Re: Florida Power & Light Company
Proposed Turkey Point Units 6 and 7
Docket Nos. 52-040 and 52-041
Response to NRC Request for Additional Information Letter No. 58 (eRAI 6434) -
Concerning Implementation of Fukushima Near-Term Task Force Recommendations

Attachment: FPL Response to NRC RAI No. 01.05-1 (eRAI 6434)

NRC RAI Number: 01.05-1 (eRAI 6434)

Figure 4: CEUS Hard Rock Hazard Results for 0.5 Hz Spectral Acceleration

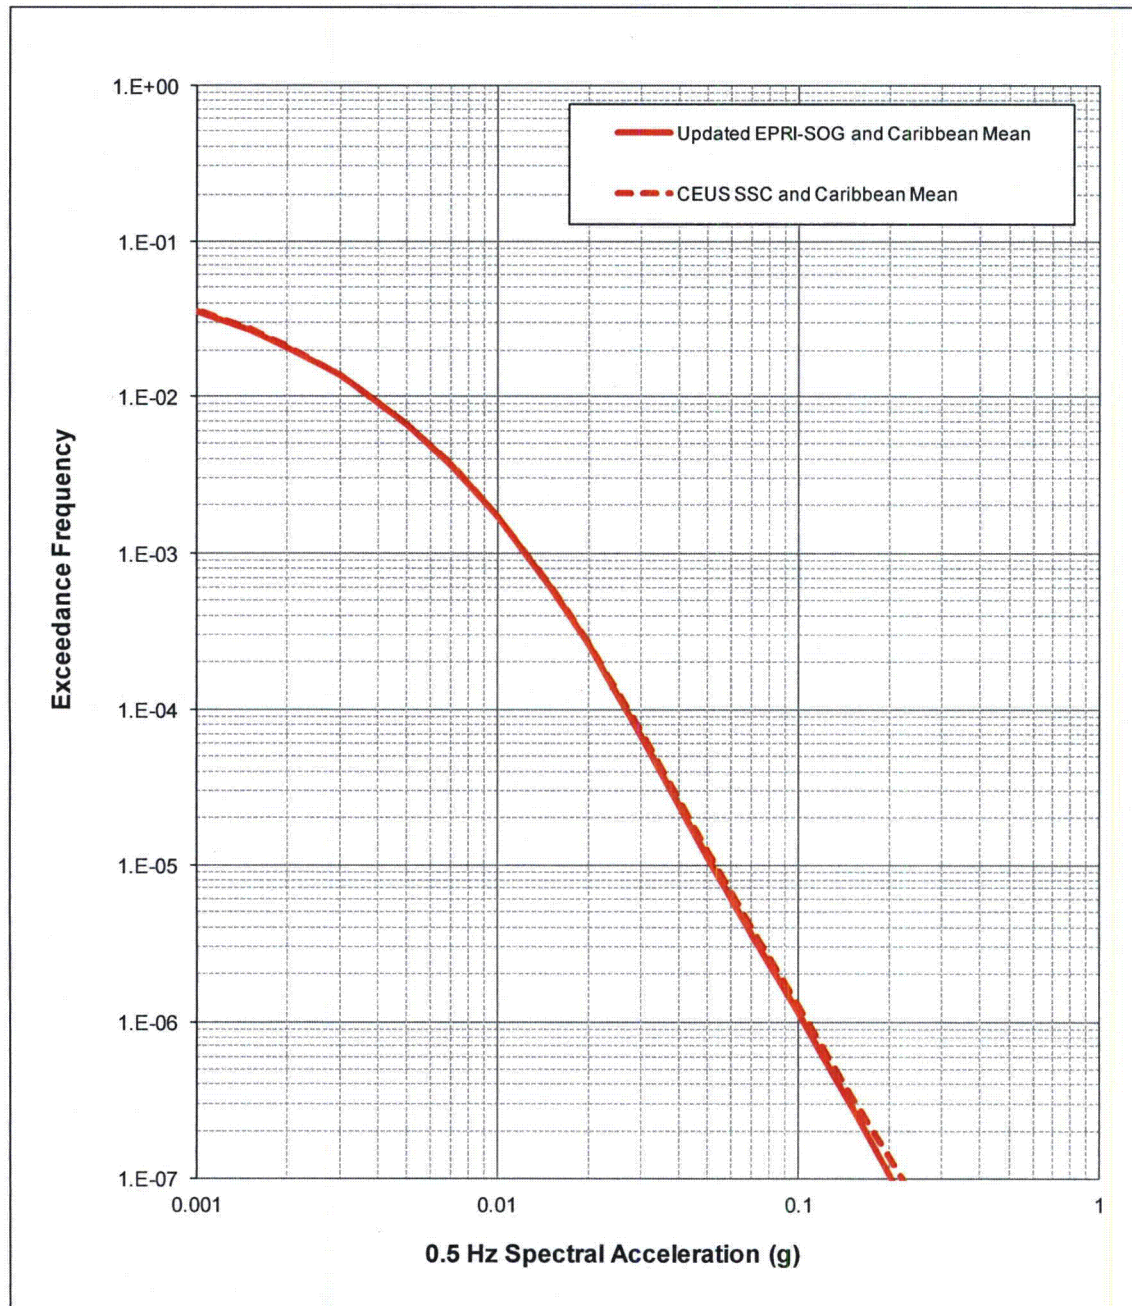
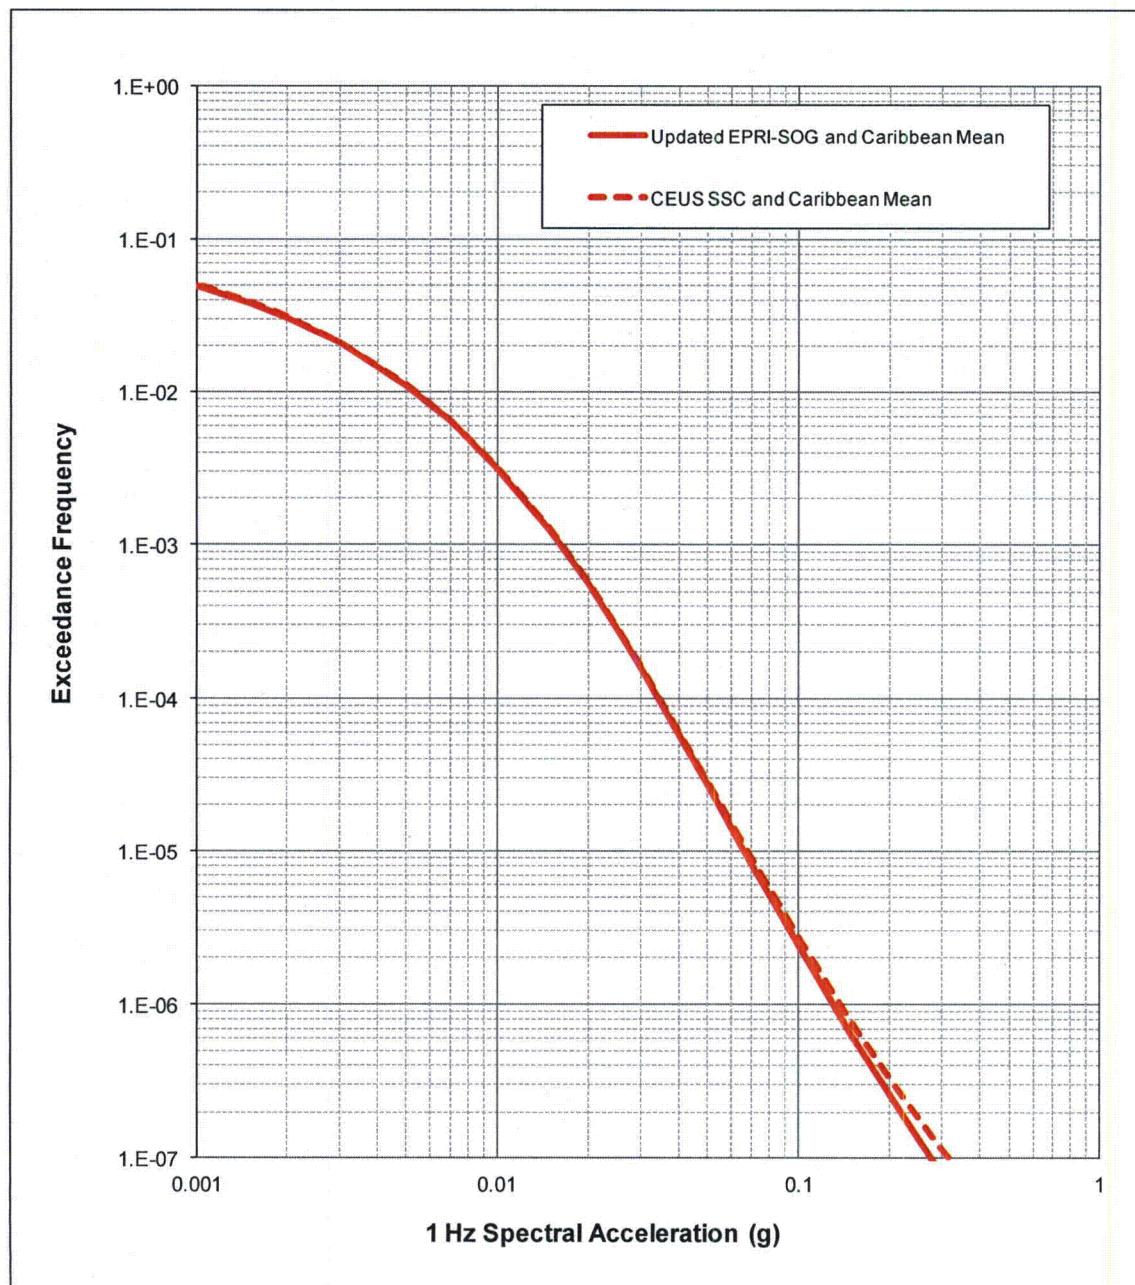
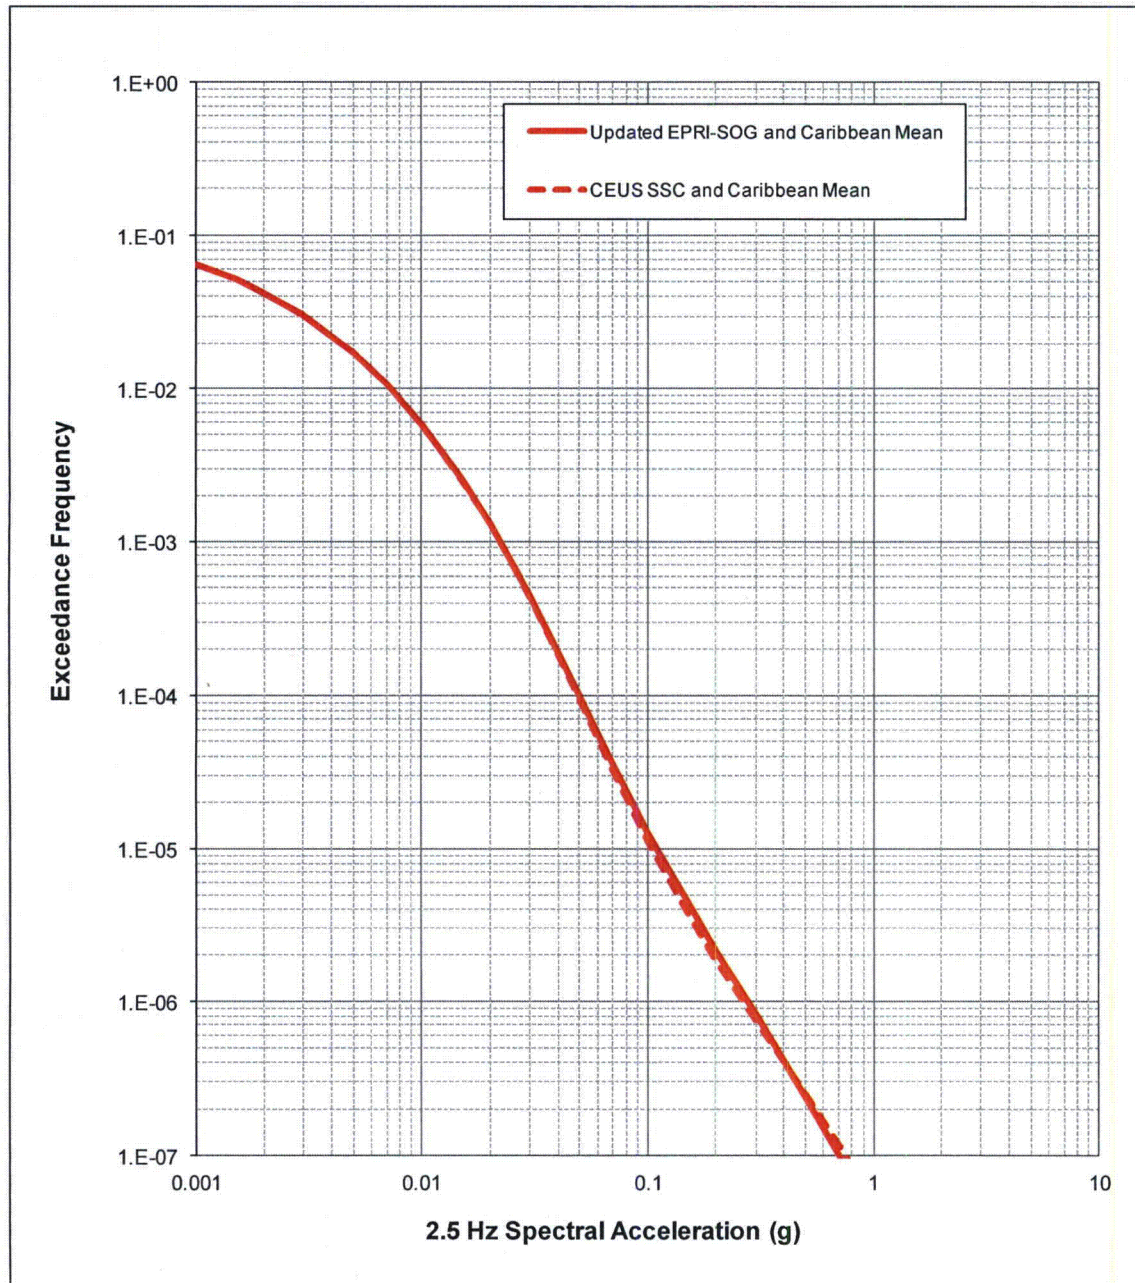
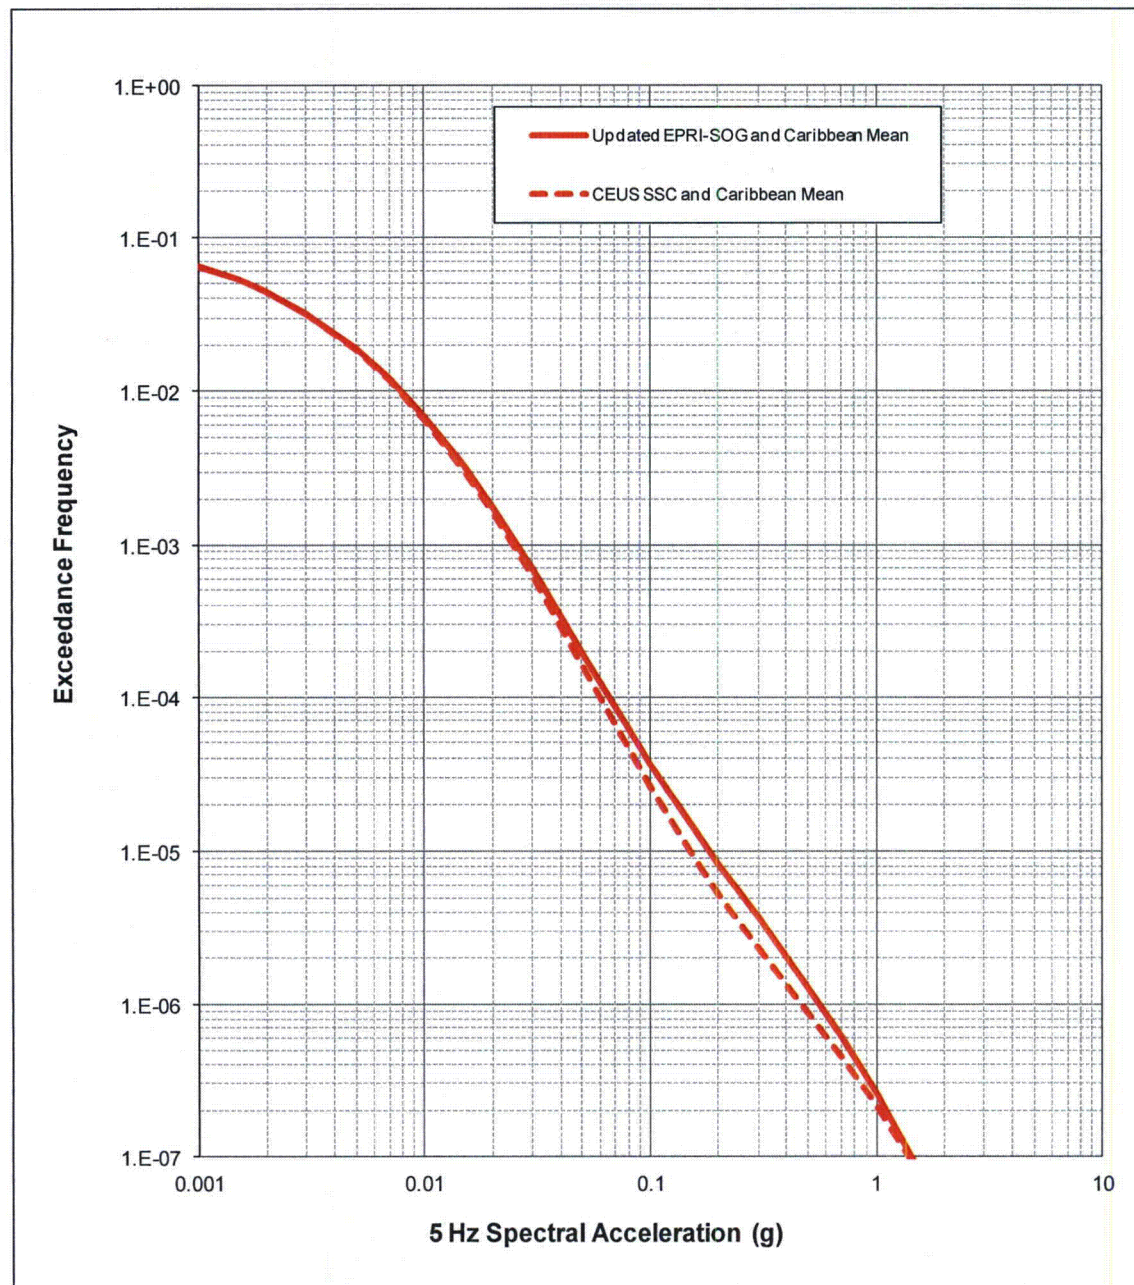
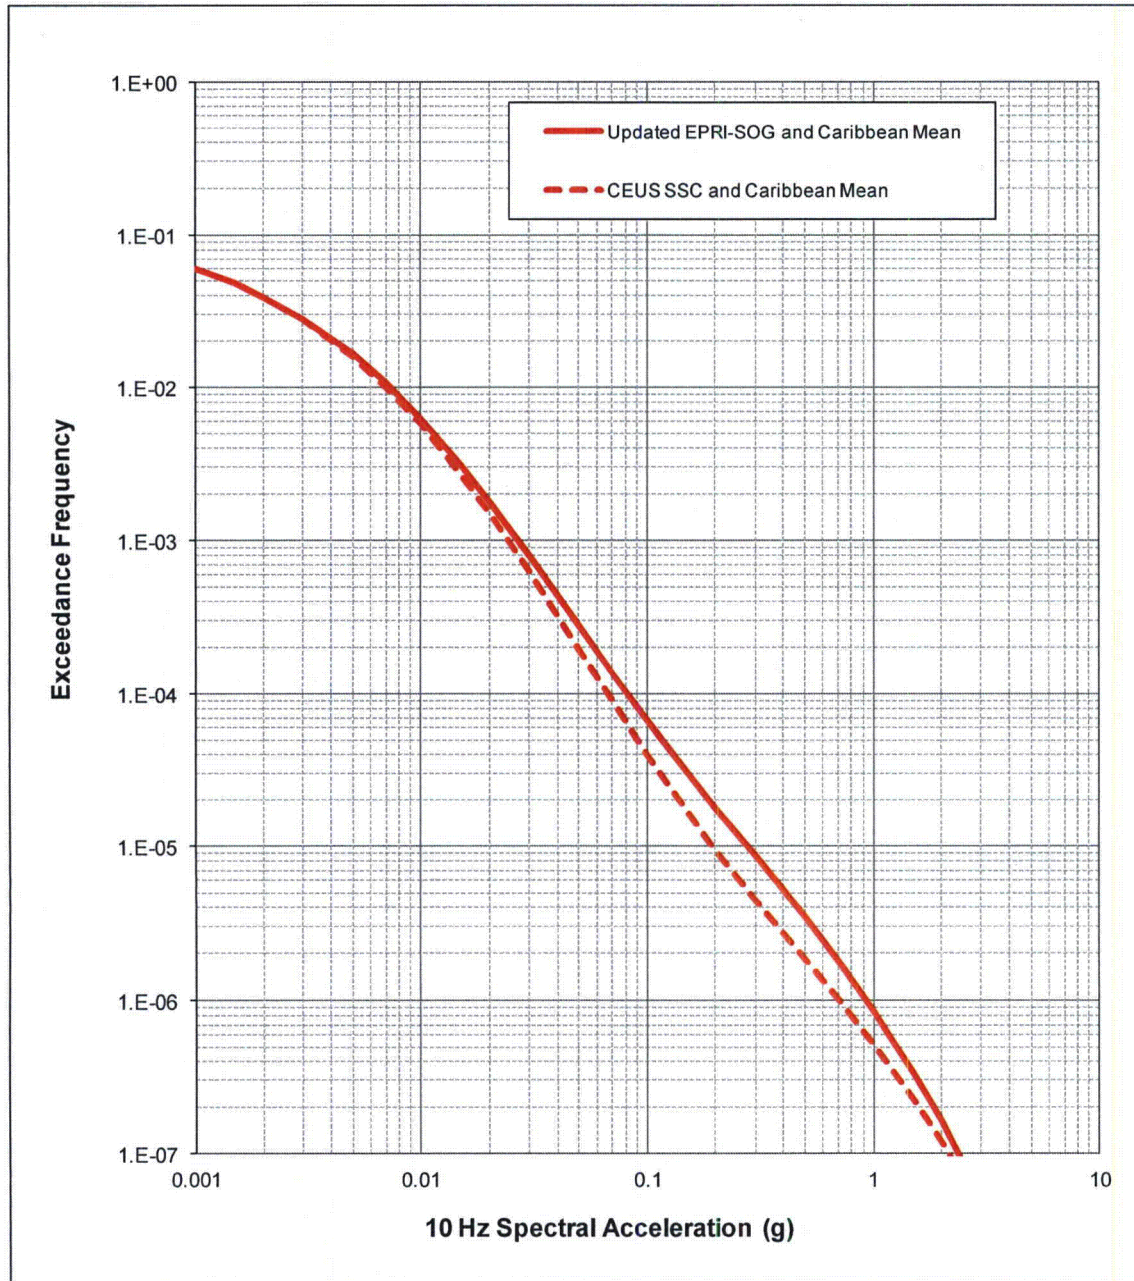
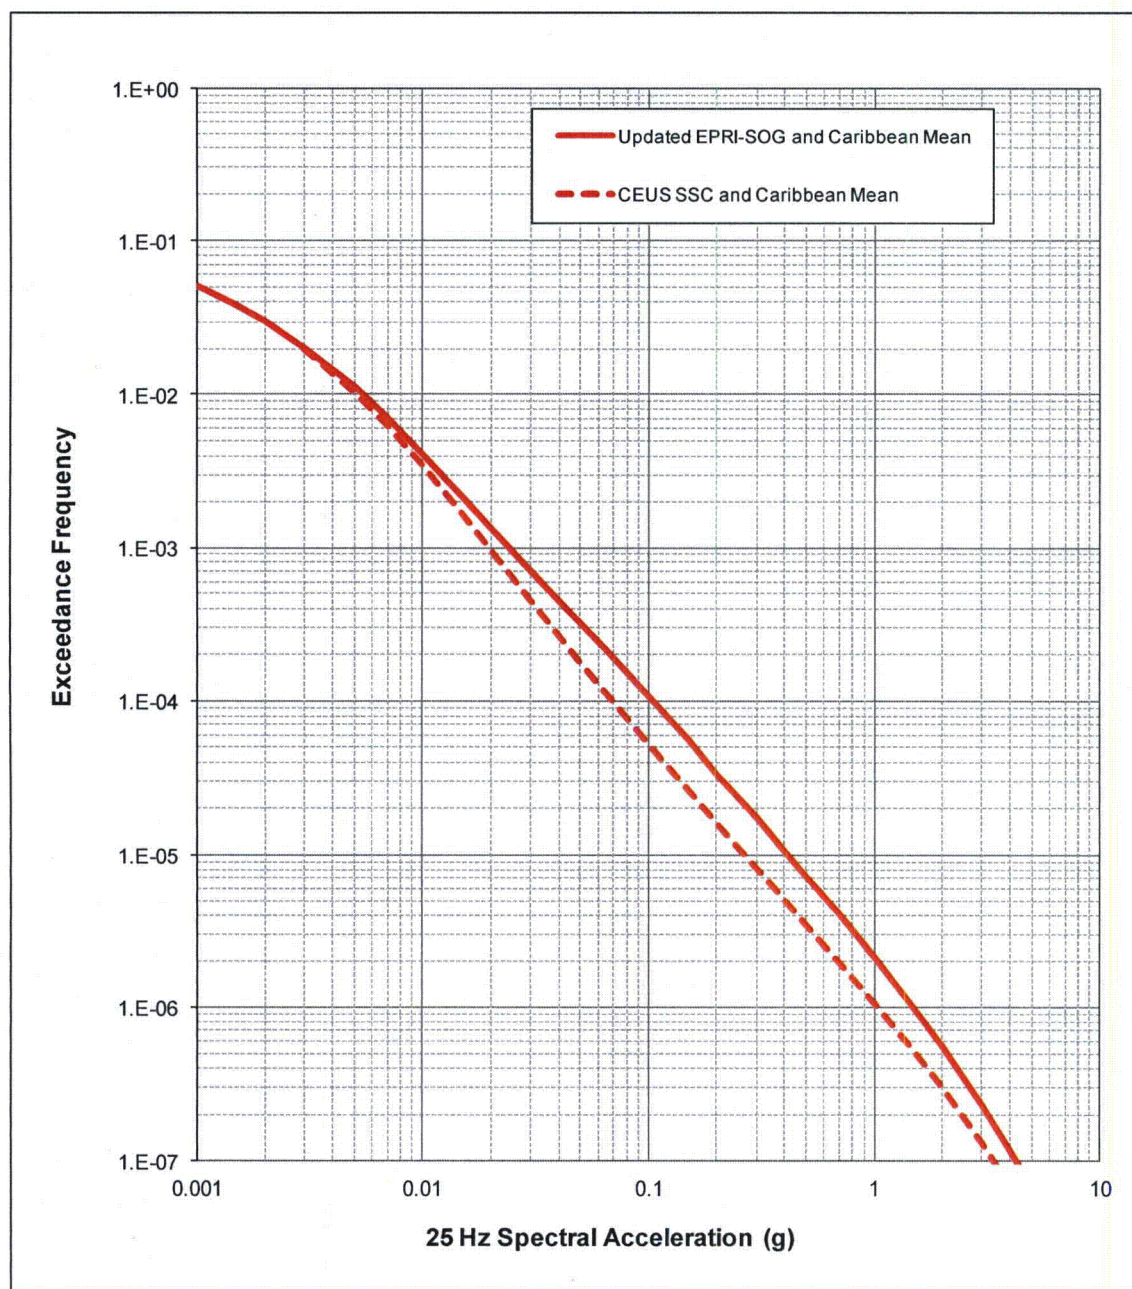
- a) Evaluate the potential impacts of the newly released CEUS SSC model, with potential local and regional refinements as identified in the CEUS SSC model, on the seismic hazard curves and the site-specific ground motion response spectra (GMRS)/foundation input response spectra (FIRS). For re-calculation of the PSHA, please follow either the cumulative absolute velocity (CAV) filter or minimum magnitude specifications outlined in Attachment 1 to Seismic Enclosure 1 of the March 12, 2012 letter "Request for information pursuant to Title 10 of the *Code of Federal Regulations* 50.54(f) regarding Recommendations 2.1, 2.3, and 9.3, of the near-term task force review of insights from the Fukushima Dai-Ichi accident." (ML12053A340).
- b) Modify the site-specific GMRS and FIRS if you determine changes are necessary given the evaluation performed in part a) above.

Figures 4 through 10 compare the total mean hazard from the updated EPRI-SOG plus Caribbean sources presented in Subsection 2.5.2.4 and Table 2.5.2-223 of the FSAR to the total mean hazard from the CEUS SSC model plus Caribbean sources. For structural frequencies of 2.5 Hz and higher, the total hazard computed using the CEUS SSC sources is lower than that computed using the updated EPRI-SOG sources in the important annual exceedance frequency range of $1\text{E-}04$ to $1\text{E-}06$. For structural frequencies of 0.5 and 1 Hz, the total hazard computed using the CEUS SSC model sources is higher by about 3 percent at an exceedance frequency of $1\text{E-}04$ and by about 11 percent at an exceedance frequency of $1\text{E-}06$. These differences in hazard for structural frequencies of 0.5 and 1 Hz are less than the suggested tolerances for hazard accuracy presented in Chapter 9 of NUREG-2115 (Reference 2).
